**AGENDA**  
**ARCHITECTURAL REVIEW BOARD MEETING**  
Conference Room 102-103  
Thursday, November 13, 2025  
5:30 PM

A. **13490 Olive Blvd. (Take 5 Oil Change)**: Amended Architectural Elevations for an existing vehicle service center facility located on a 0.40-acre tract of land, zoned "C2" Shopping District with Conditional Use Permit No. 17.

## Architectural Review Board Staff Report

**Description:** **13490 Olive Blvd. (Take 5 Oil Change):** Amended Architectural Elevations for an existing vehicle service center facility located on a 0.40-acre tract of land, zoned "C2" Shopping District with Conditional Use Permit No. 17.

Figure 3: West and North Elevation

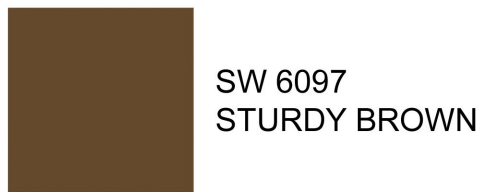
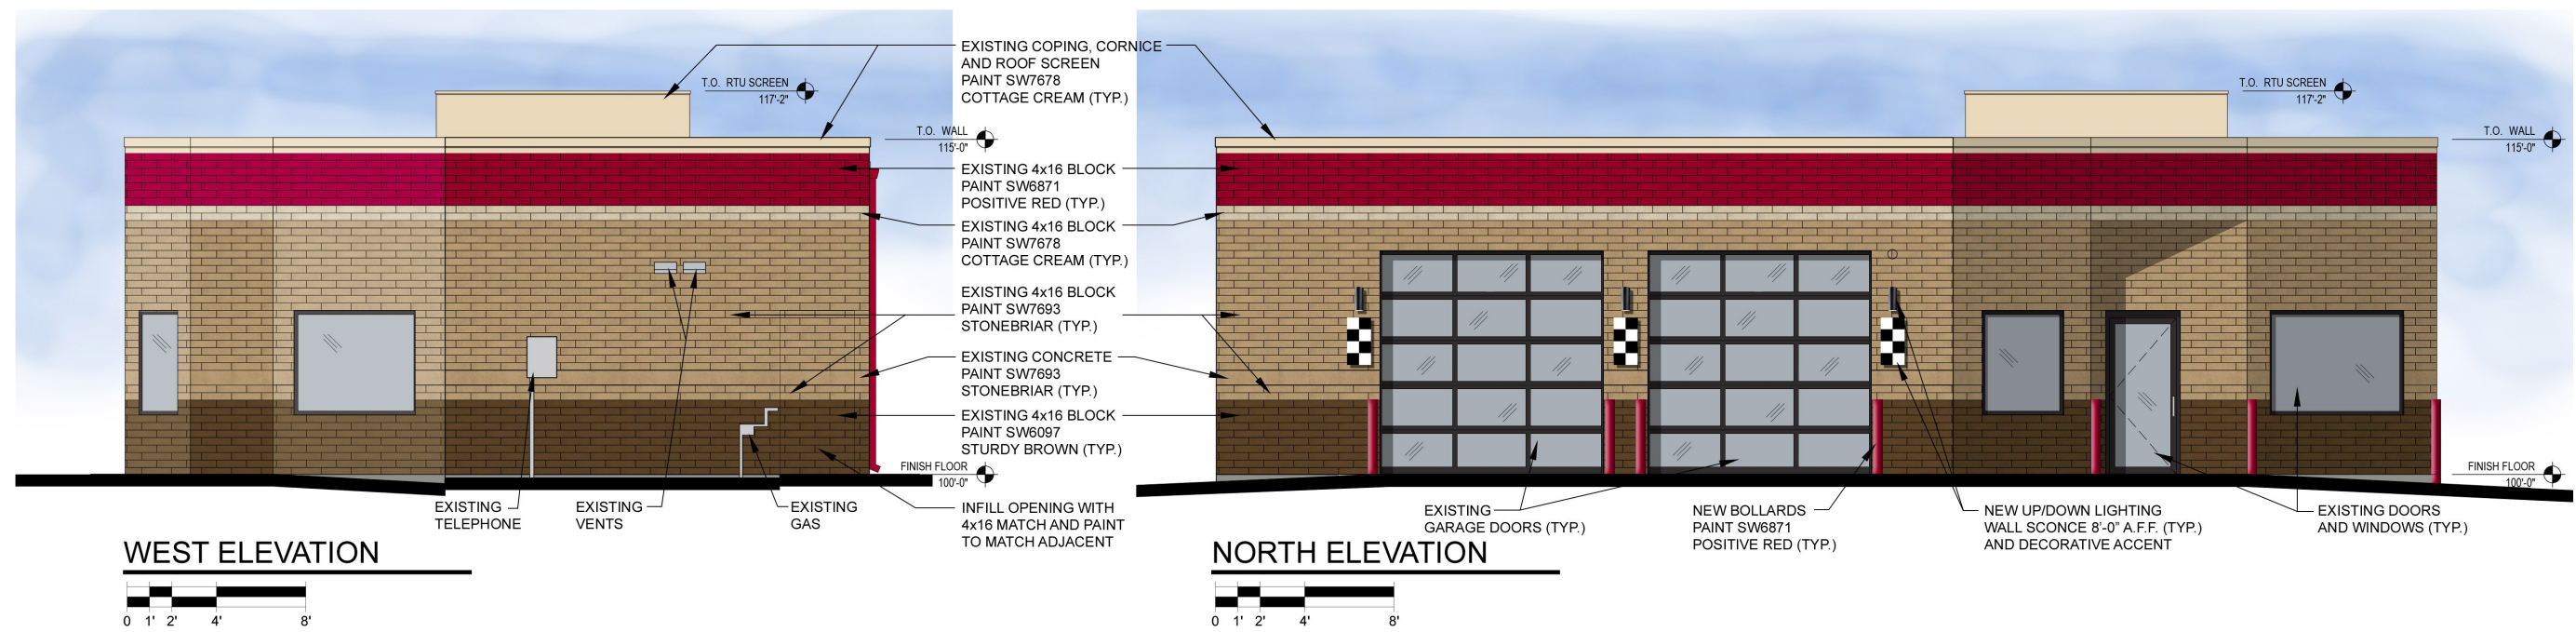
All four (4) sides of the building façades are proposed to be wrapped in four (4) different colors. The upper brick portion will be painted Positive Red, followed by a cream-colored painted brick band. The dominant color on all sides will be painted Stonebriar, and the base brick will be finished in Sturdy Brown color. Additionally, new decorative accents are proposed near the overhead doors on the north elevation.

The applicant is proposing new wall pack lights on the north and south elevations. The north elevation is proposed to have three (3) wall sconces mounted at a height of 8 feet. The south elevation will have an LED wall pack with a remote battery pack. The cylindrical sconce proposed on the north elevation is not fully shielded and will require Planning Commission approval.
